CHAMPLAIN HUDSON POWER EXPRESS
SEGMENT 12 (PACKAGE 7B) - ROUTE 9W: ROCKLAND
OFF SITE ACCESS ROADS
SHEET 2 OF 2

No.	DATE	SUBMITTAL / REVISION DESCRIPTION	DB	APP	1	12/22/2023	NDC-0023: HOSPITAL BORE REMOVED	MRS	EJK	0	07/20/2023	ISSUED FOR CONSTRUCTION SUBMISSION	MRS	EJK	<p>CHAMPLAIN HUDSON POWER EXPRESS SEGMENT 12 (PACKAGE 7B) - ROUTE 9W: ROCKLAND</p> <p>PLAN AND PROFILE - HDD 127 PAGE 1 OF 2 UTILITY CROSSING - CONDUIT 1 ROCKLAND COUNTY, NY</p>	<p>PERMIT DRAWING NO. N/A</p> <p>DRAWING NO. C-327</p>
No.	DATE	SUBMITTAL / REVISION DESCRIPTION	DB	APP																		
1	12/22/2023	NDC-0023: HOSPITAL BORE REMOVED	MRS	EJK																		
0	07/20/2023	ISSUED FOR CONSTRUCTION SUBMISSION	MRS	EJK																		
<p>PROJECT NO.: 21162 PROJECT NO.: 204-3701 ALTERED ON: AFFIXED ON: 12/22/2023</p>					<p>12/22/2023 MRS EJK</p>	<p>SCALE: AS SHOWN DATE: 07/20/2023</p>	<p>DRAWN BY: MRS DESIGNED BY: AMC APPROVED BY: EJK</p>

CHAMPLAIN HUDSON POWER EXPRESS
SEGMENT 12 (PACKAGE 7B) - ROUTE 9W: ROCKLAND
EROSION AND SEDIMENT CONTROL PLAN
STA. 72500+00.00 TO STA. 72530+00.00

PERMIT DRAWING NO.	N/A
DRAWING NO.	C-202

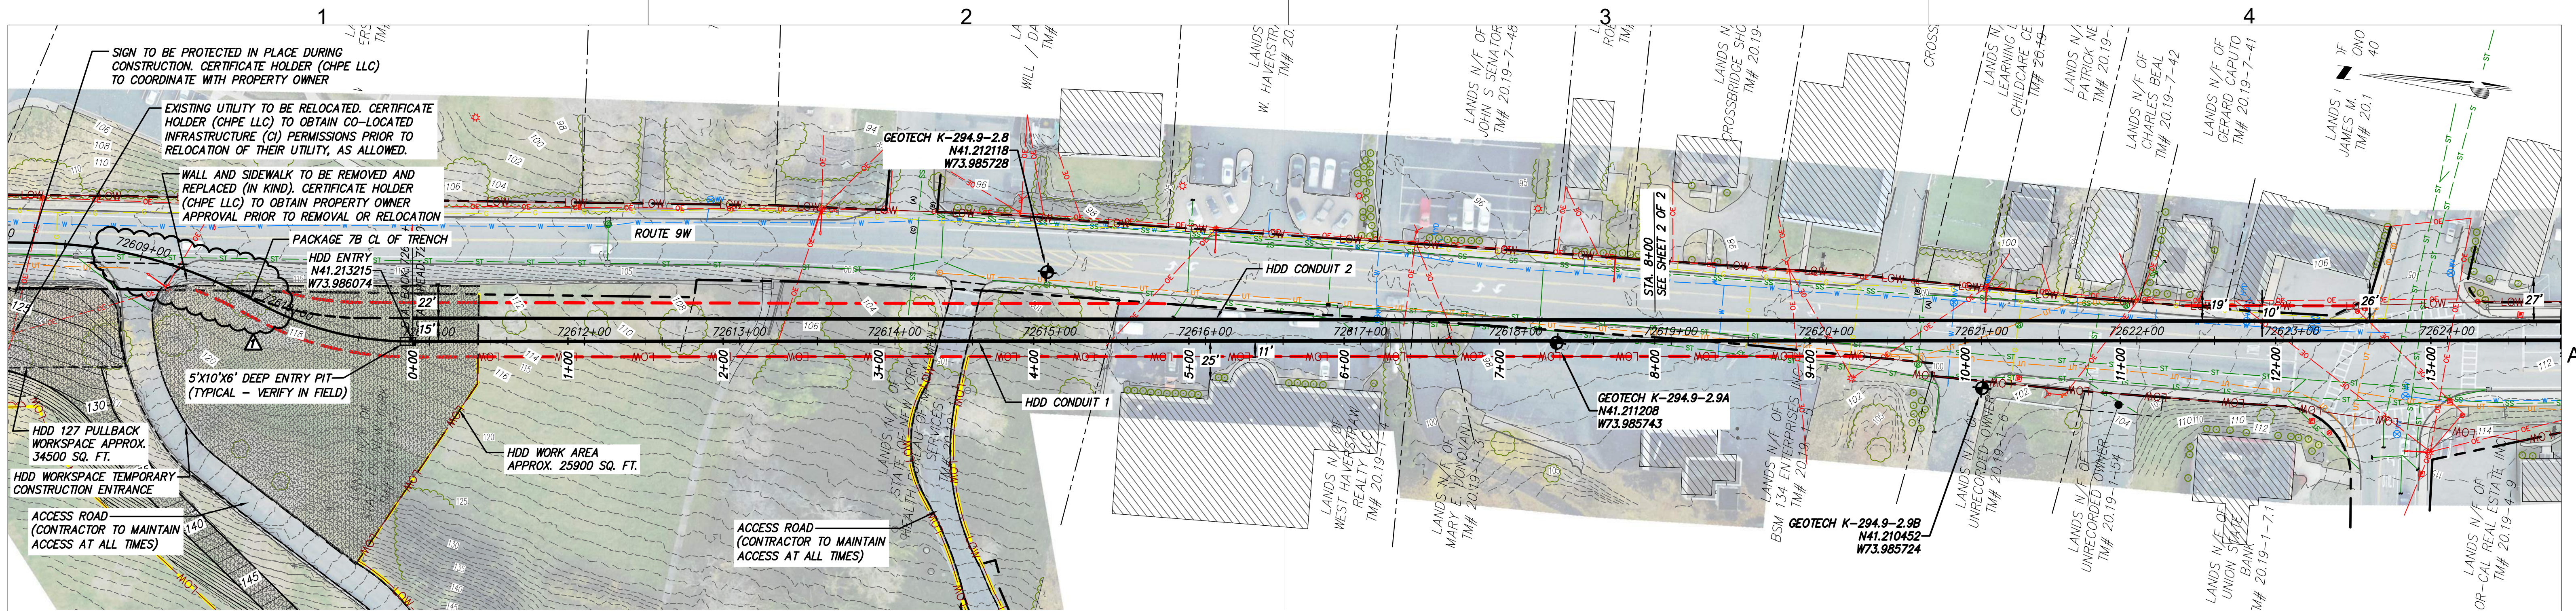
No.	DATE	SUBMITTAL / REVISION DESCRIPTION	DB	APP
1	12/22/2023	GRAVEL WORKING SURFACE ADDED	RB	JL
1	12/22/2023	NDC-0023: HOSPITAL BORE REMOVED	RB	JL
0	07/20/2023	ISSUED FOR CONSTRUCTION SUBMISSION	RB	JL

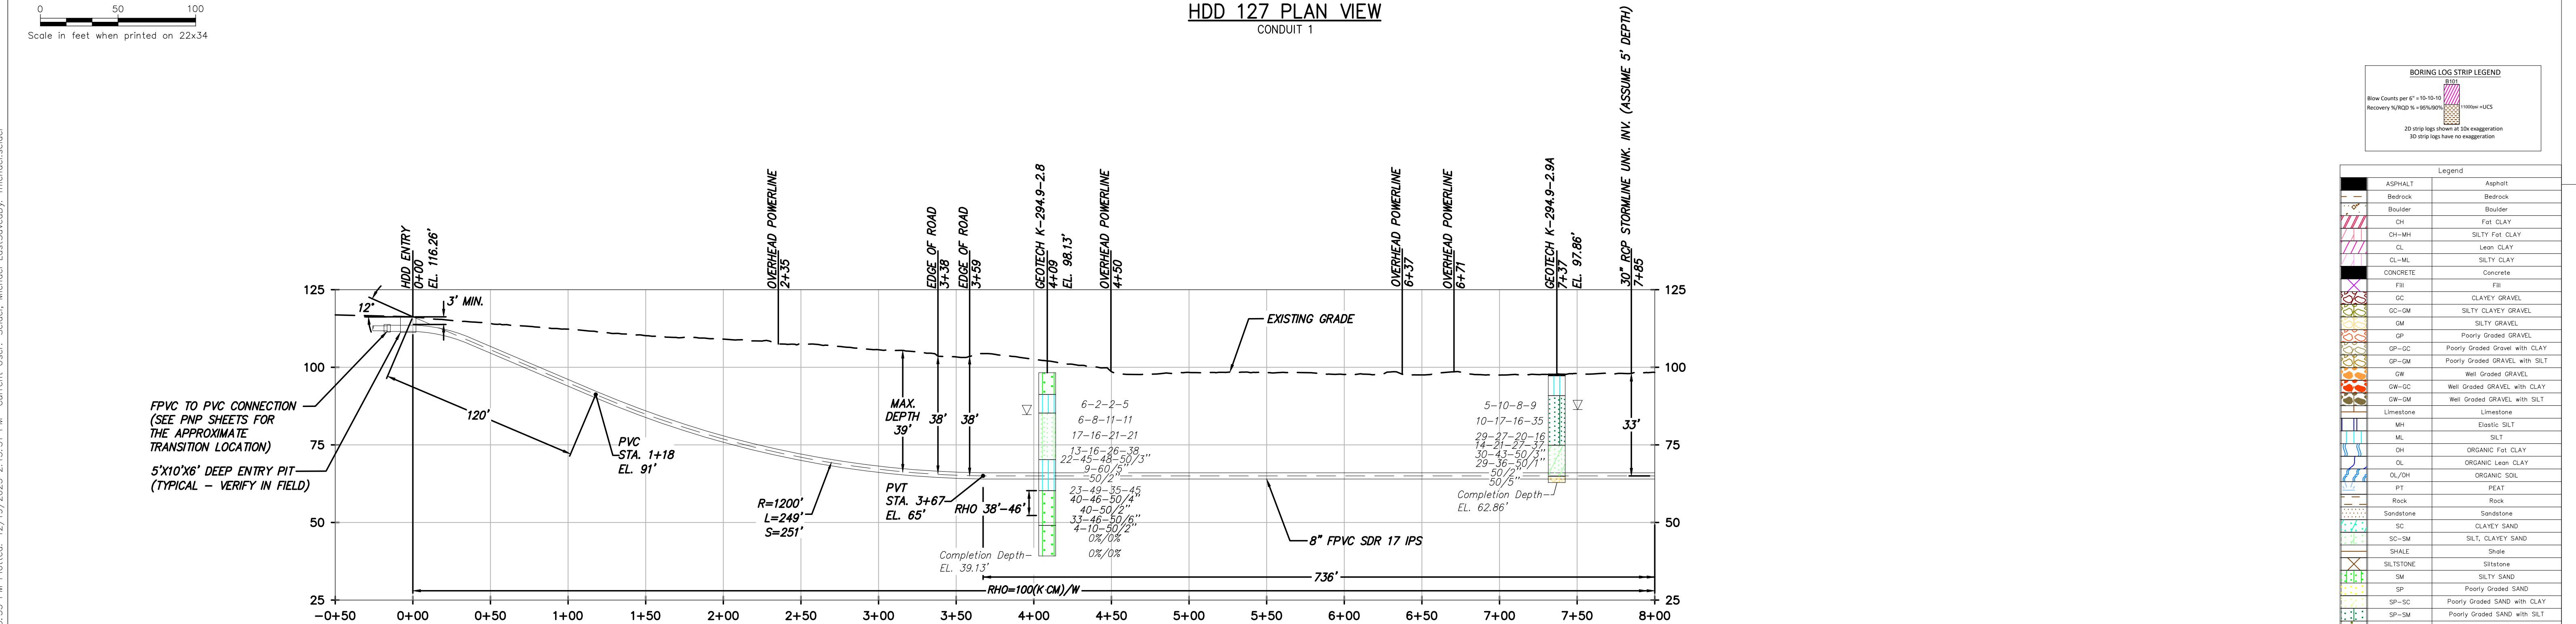
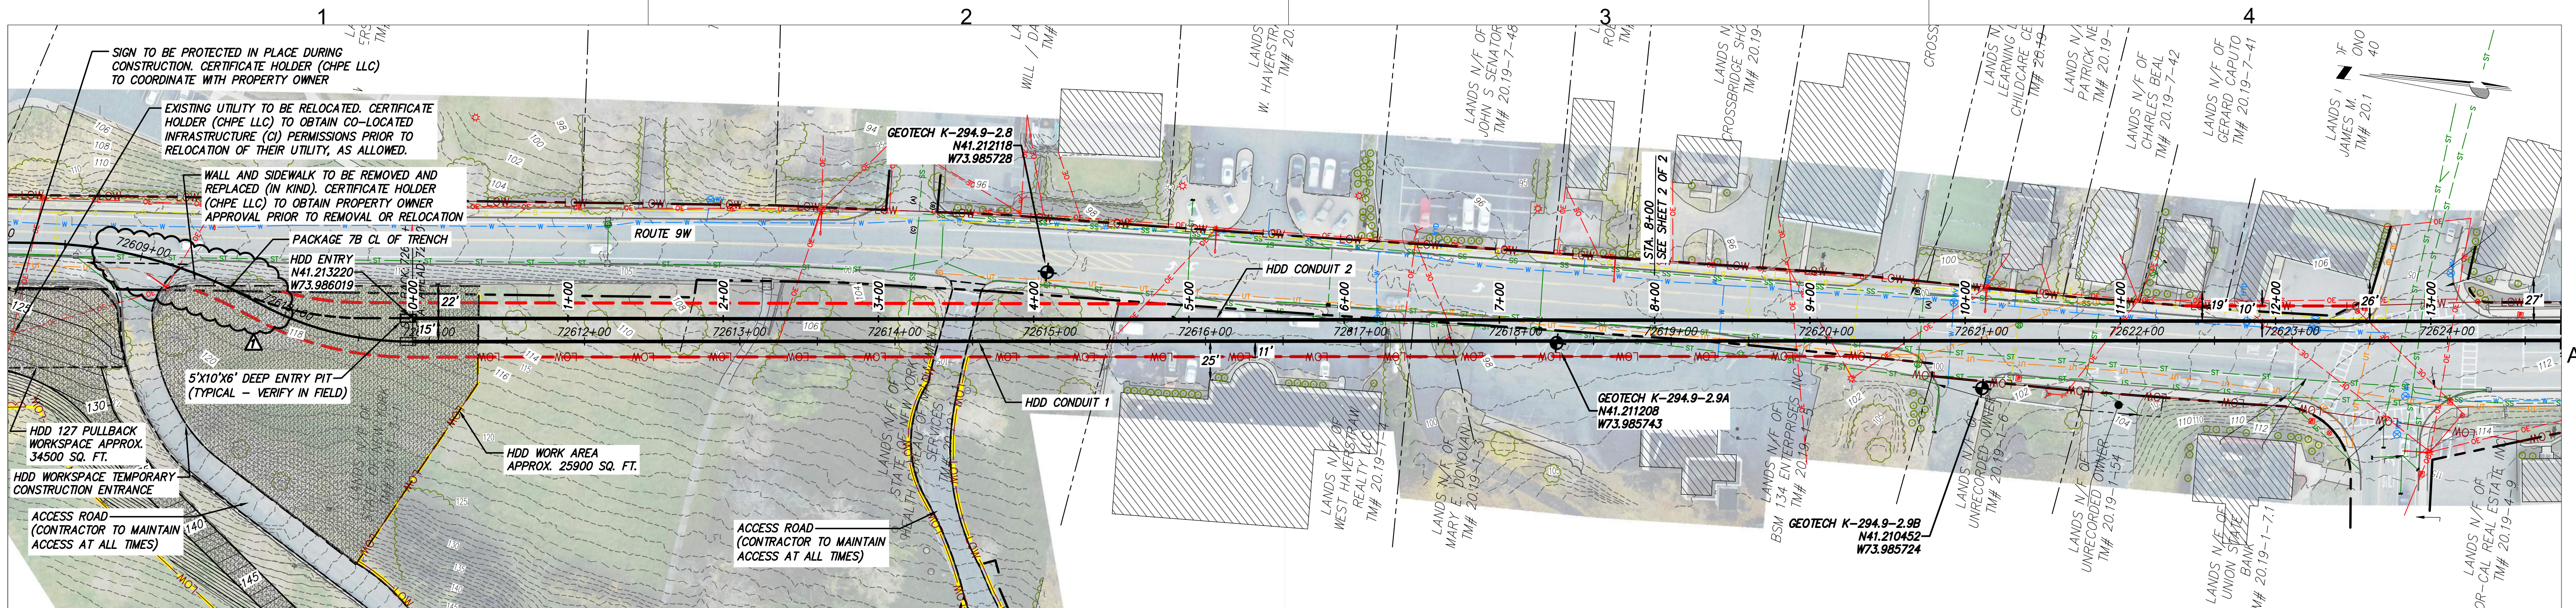
<table><tr><td>No.</td><td>DATE</td><td>SUBMITTAL / REVISION DESCRIPTION</td><td>DB</td><td>APP</td></tr><tr><td>1</td><td>12/22/2023</td><td>NDC-0023: HOSPITAL BORE REMOVED</td><td>MRS</td><td>EJK</td></tr></table>
